SCOPING OPINION:

Proposed Castle Way Energy

Case Reference: EN0110037

28 July 2026

The industrialisation that will surround Church Broughton if this proposal proceeds.

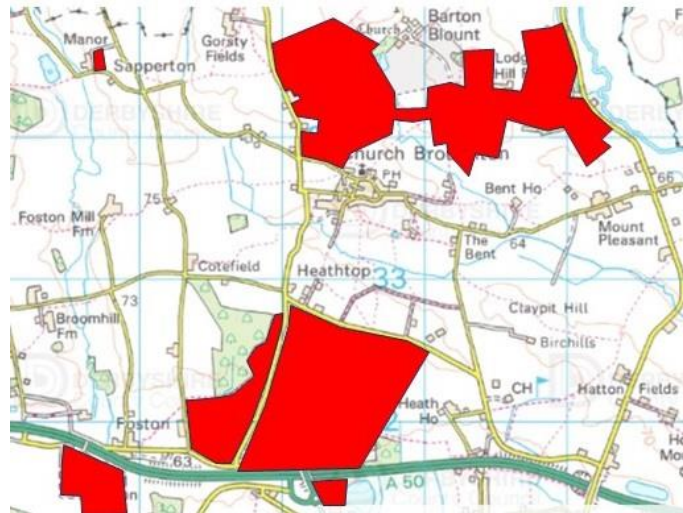
Clause 7.5.10 deals with sources of Air pollution. It appears to rule out any large industrial sources within the study area which are likely to impact the Proposed Development, but does not comment on other (i.e. “non large”) industrial sources. The CBPC is seeking that the Dove Valley Park Industrial Estate and the proposed plasterboard recycling facility that is currently going through Derbyshire County Council’s planning approval process for a location on Woodyard Lane just to the South of Church Broughton to be included in a background assessment of current and future sources of particulate and wider air pollution. If approved, this plasterboard recycling facility will be an extra source of notable air pollution that the Applicant’s solar proposal will contribute to incrementally. The current Dove Valley Park Industrial Estate development and proposed plasterboard development on Woodyard Lane development are directly South West of the village i.e. in line with the main prevailing wind direction. Church Broughton and its primary school (for 4-11 years old) would be ‘sandwiched’ directly between the current industrial developments and this proposed development

(see the picture below). The resulting combined effects of pollutants should be considered and, in particular, in the Construction and Decommissioning phases.

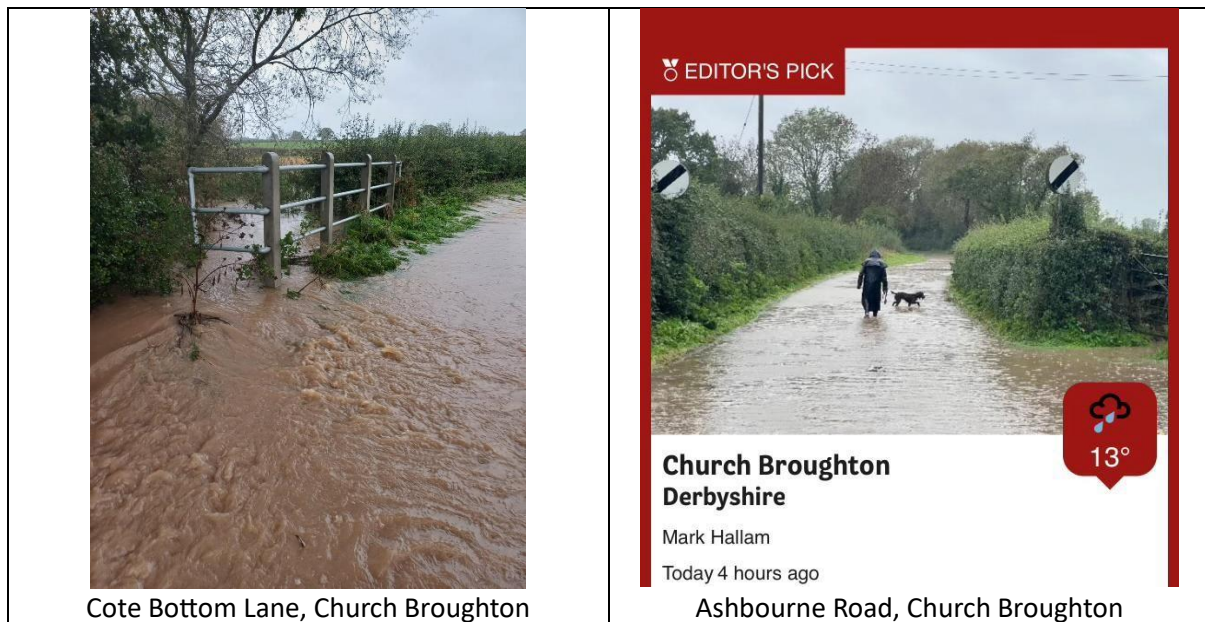
Clauses 19.6.5 does not accurately describe the severity of local flooding. This happens on several occasions per year in Site B. The topography of the land does not just fall from West to East but also North to South with rainfall run-off coming from fields in Site B onto its local the roads and also moving further South. This isolates the village of Church Broughton every year and impacts the school which has to close. This then further impacts parents at work who have to collect children when an emerging “access risk” is communicated. This needs comprehensive assessment and inclusion. Also within clause 19.6.5 Site B is shown to lie in Flood Zone 1 on the Flood Map for Planning as the ordinary watercourses within the site have not been modelled at the upstream extents of their catchments. The surface water flood maps indicate that Site B is expected to have areas of land in Flood Zones 2 and 3. Hydrological assessment and hydraulic modelling is required to assess the extent of the Flood Zones within Site B. This must be included in the Flood Risk Assessment.

Within clauses 19.6.14 and 15 there are a number of areas at high, medium and low risk of surface water flooding within site B, not just small pockets, which become more extensive in the years between 2040 and 2060. There are also significant high risk surface water events (not just low and medium events) associated with the ordinary watercourses and also areas of high risk of surface water flooding on the east and west sides of Site B.

Figure 4.2: Derby Airfield (EGBD) showing impact of development on the Aerodrome Traffic Zone (ATZ)

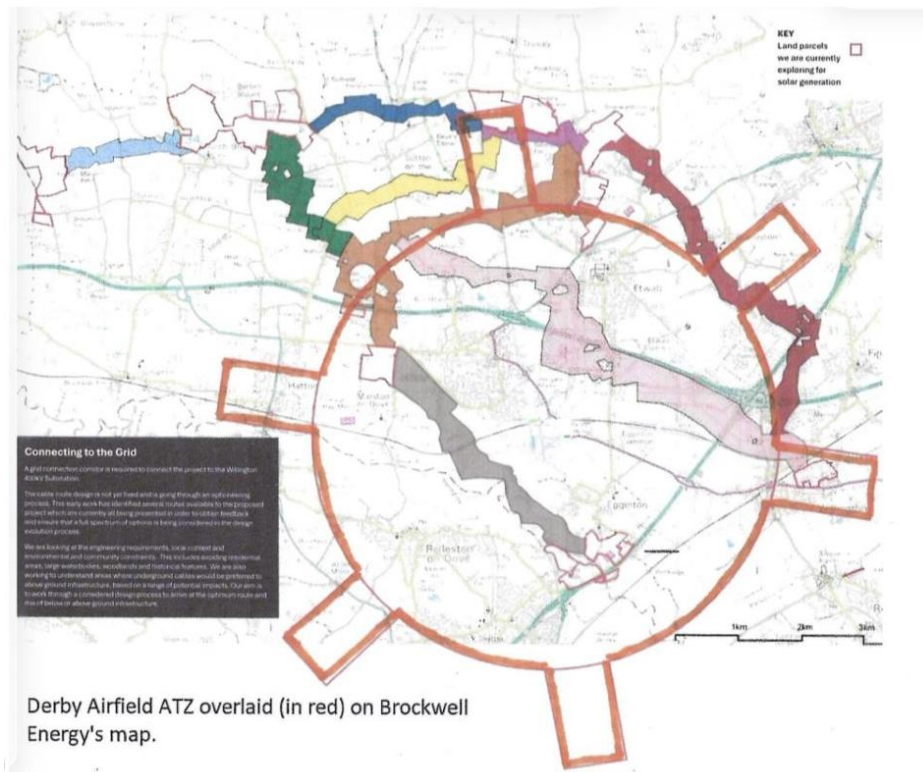
- 4.13. Because the airfield operates active flight training circuits and low-altitude light aircraft approaches over these exact land parcels, its active runways and operational airspace create a constrained visual baseline. This proximity legally mandates a specialised Glint and Glare impact assessment within the ES to evaluate potential solar reflection safety risks to pilots on their final approach thresholds.

- 4.14. A large-scale solar array immediately adjacent to a licensed grass aerodrome is not a routine glint-and-glare receptor case: the airfield operates visual-flight-rules circuits at low altitude directly over the parcel; aircraft are constrained in their ability to manoeuvre around reflective sources during base-leg and final approach; and the proximity falls within the consultation distance for aerodrome safeguarding under the DfT/CAA Safeguarding of Aerodromes – ODPM Circular 1/2003 regime and CAP 738 – Safeguarding of Aerodromes.

- The Scoping Report Figure 15.2 is copied below...

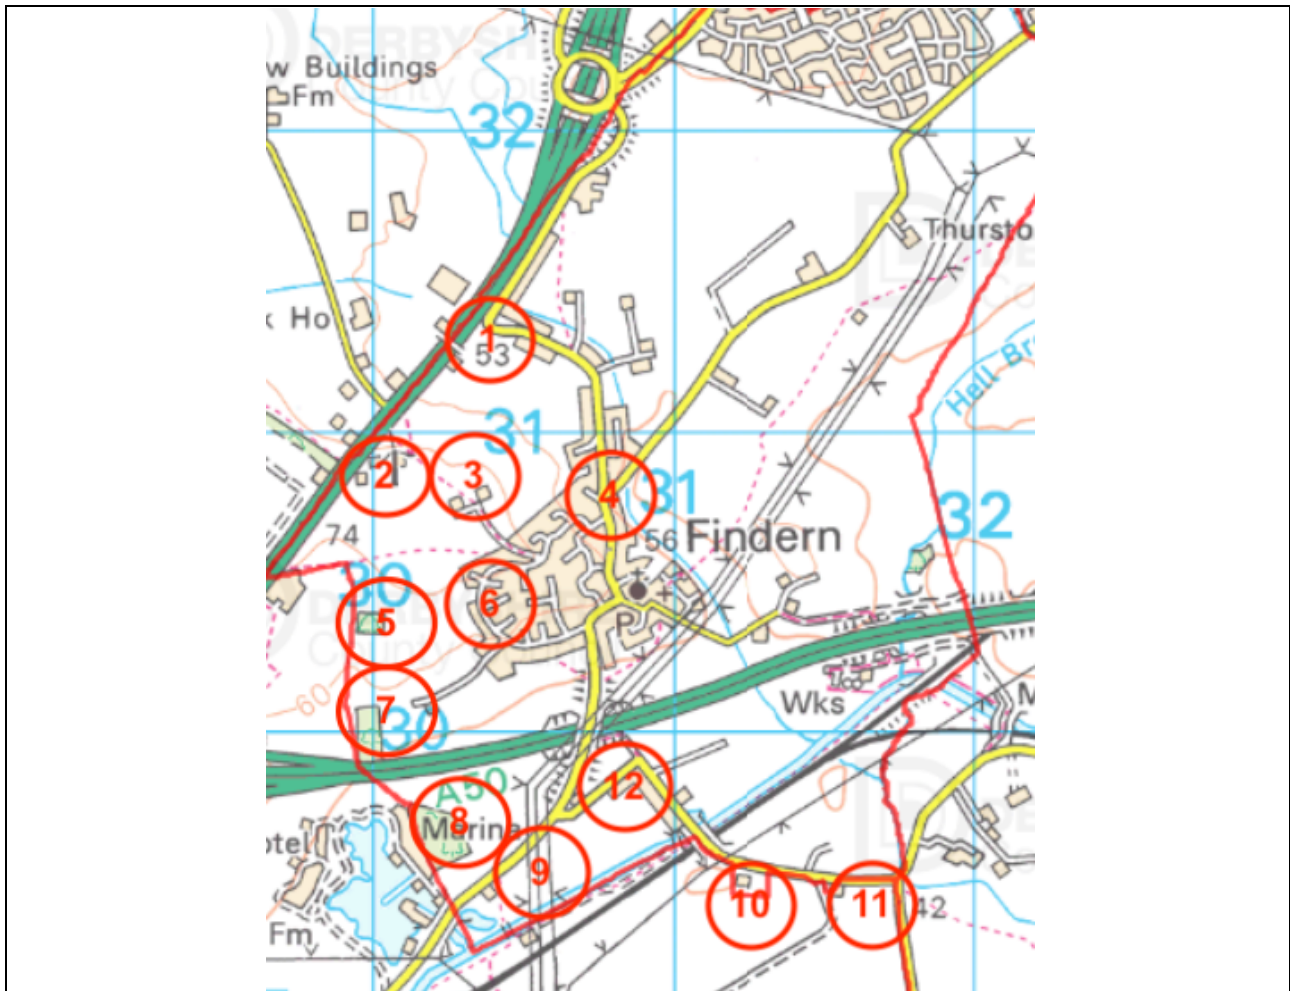
- The top section of this table includes Etwall, Eggington and Willington, but does not include Findern. It is possible that Findern will not see significant visual effects.
- **It is recommended that Findern is added to the top section of this table**

Figure 4.2: Derby Airfield (EGBD) showing impact of development on the Aerodrome Traffic Zone (ATZ)

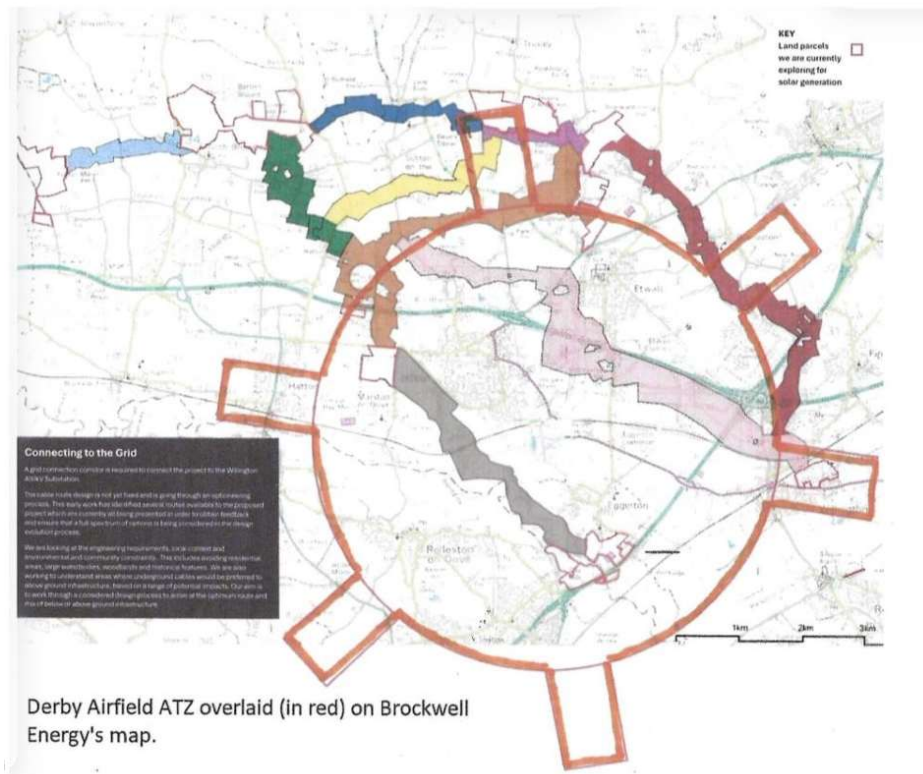
- 4.13. Because the airfield operates active flight training circuits and low-altitude light aircraft approaches over these exact land parcels, its active runways and operational airspace create a constrained visual baseline. This proximity legally mandates a specialised Glint and Glare impact assessment within the ES to evaluate potential solar reflection safety risks to pilots on their final approach thresholds.

- 4.14. A large-scale solar array immediately adjacent to a licensed grass aerodrome is not a routine glint-and-glare receptor case: the airfield operates visual-flight-rules circuits at low altitude directly over the parcel; aircraft are constrained in their ability to manoeuvre around reflective sources during base-leg and final approach; and the proximity falls within the consultation distance for aerodrome safeguarding under the DfT/CAA Safeguarding of Aerodromes – ODPM Circular 1/2003 regime and CAP 738 – Safeguarding of Aerodromes.
